**Nomination Form
Anadromous Waters Catalog**

Anadromous Waters Catalog Number of Water Body 223-30-13230

Name of Water Body *Freshman Creek USGS Name Local Name

Nomination #	<u>25-849</u>	<u>[Signature]</u>	<u>12/09/2025</u>
		Fisheries Scientist	Date
Revision Year:	<u>2026</u>	<u>[Signature]</u>	<u>12/9/25</u>
		Habitat Operations Manager	Date
Revision to:	<input checked="" type="checkbox"/> Atlas <input checked="" type="checkbox"/> Catalog	<u>[Signature]</u>	<u>8 Dec 2025</u>
		AWC Project Biologist	Date
Revision Code:	<u>A-2d, F-1</u>	<u>[Signature]</u>	<u>12/11/2025</u>
		GIS Analyst	Date

Map #2

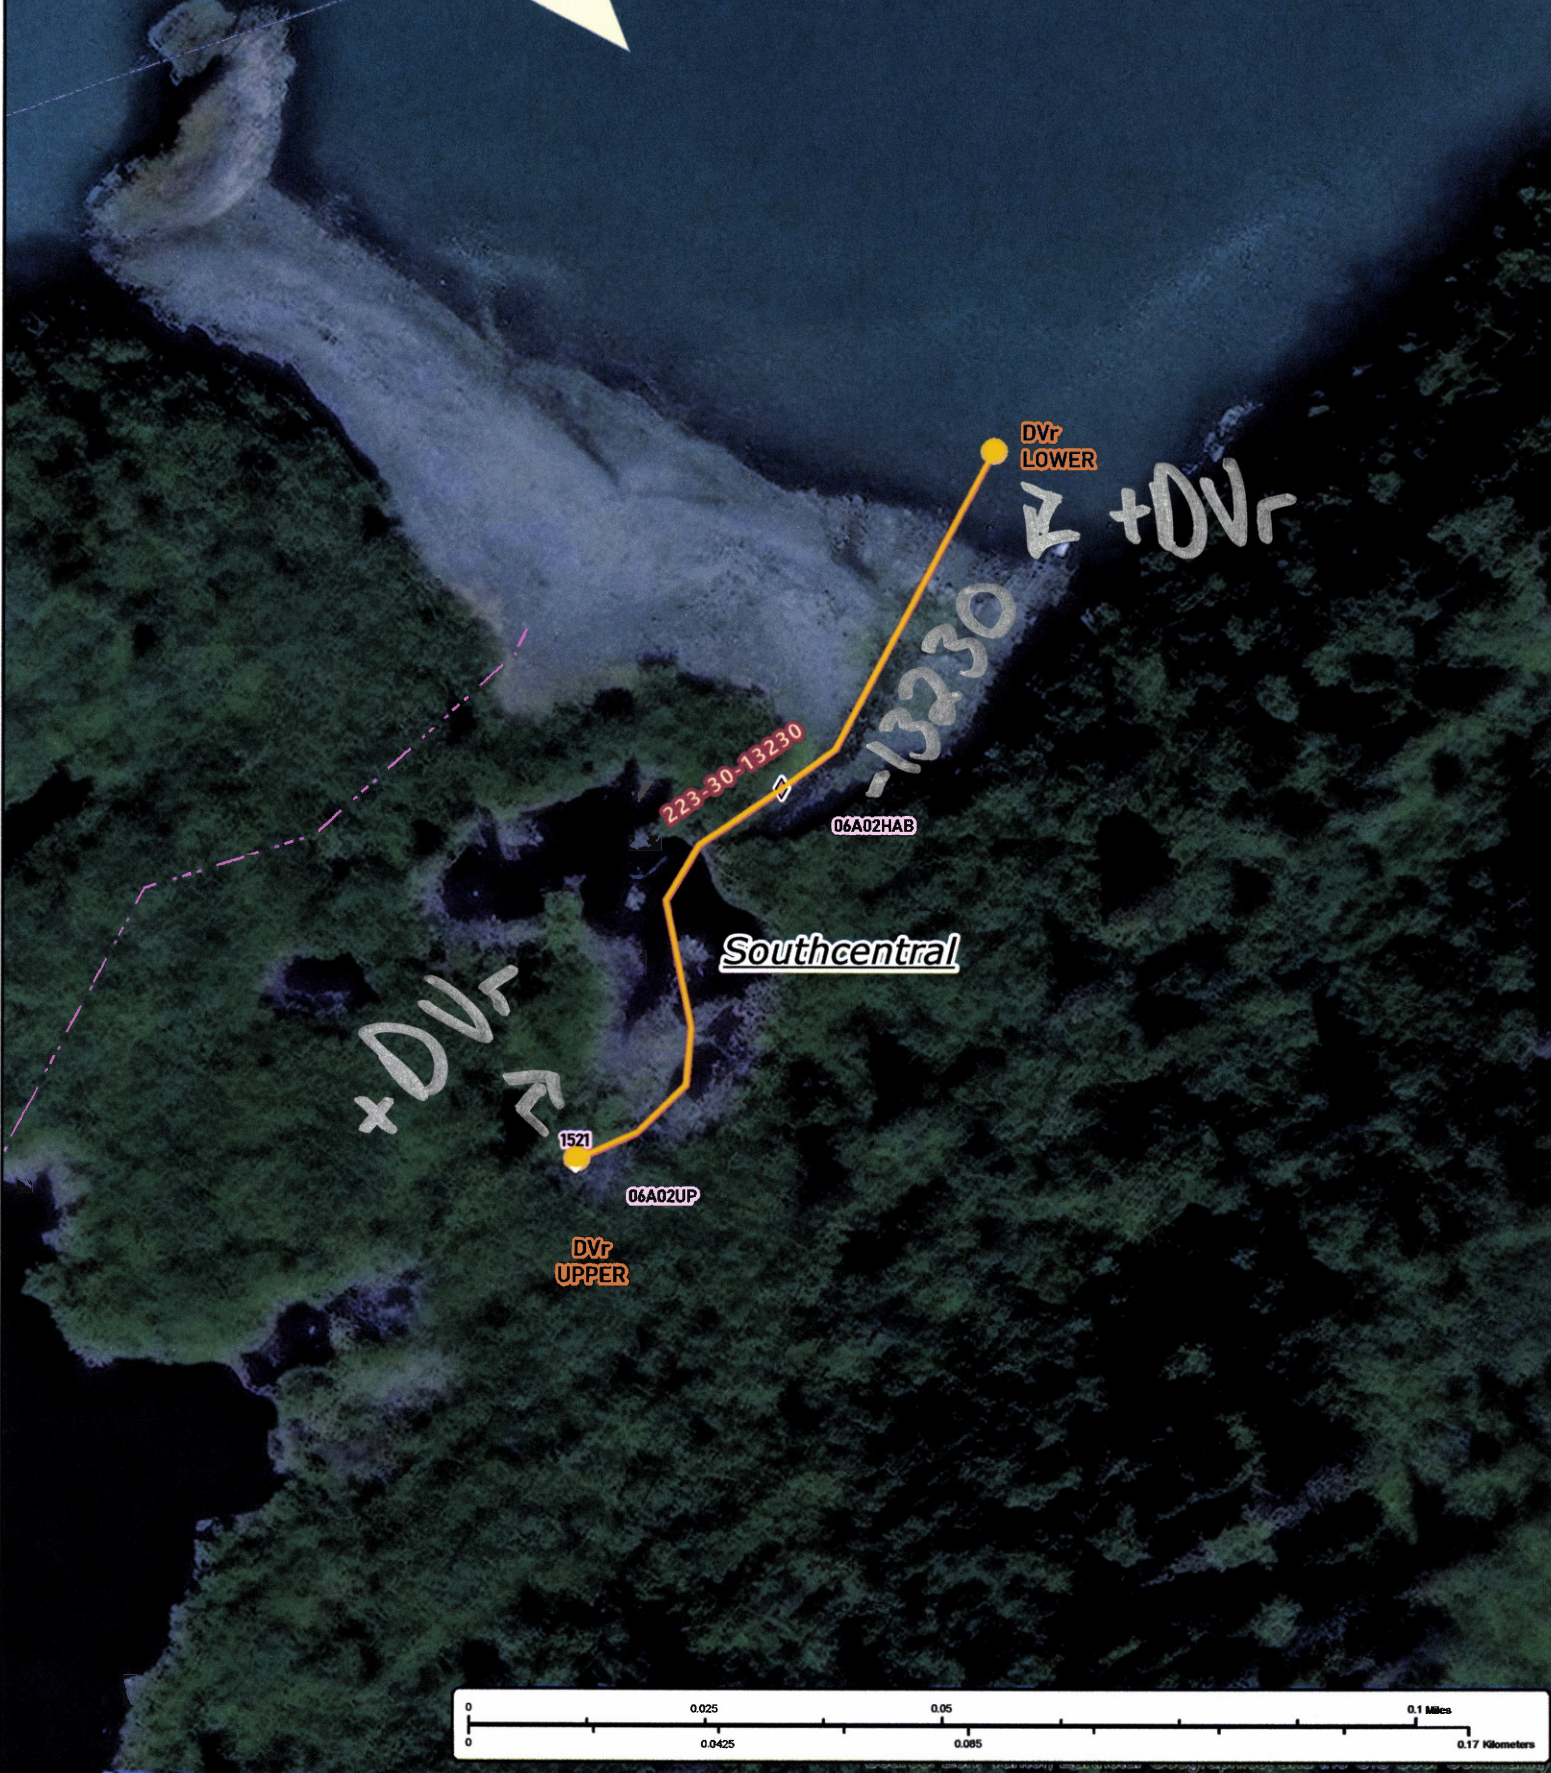
-ADD new AWC Stream #223-30-13230 "Freshman Creek" with Dolly Varden REARING.

+ Please update using most recent .GDB with line, point, lake, polygon and barrier features located in O:\DSFR5AWC\Draft2026\GIS\Data\AWC2026_WrkingV1_7April2025.gdb
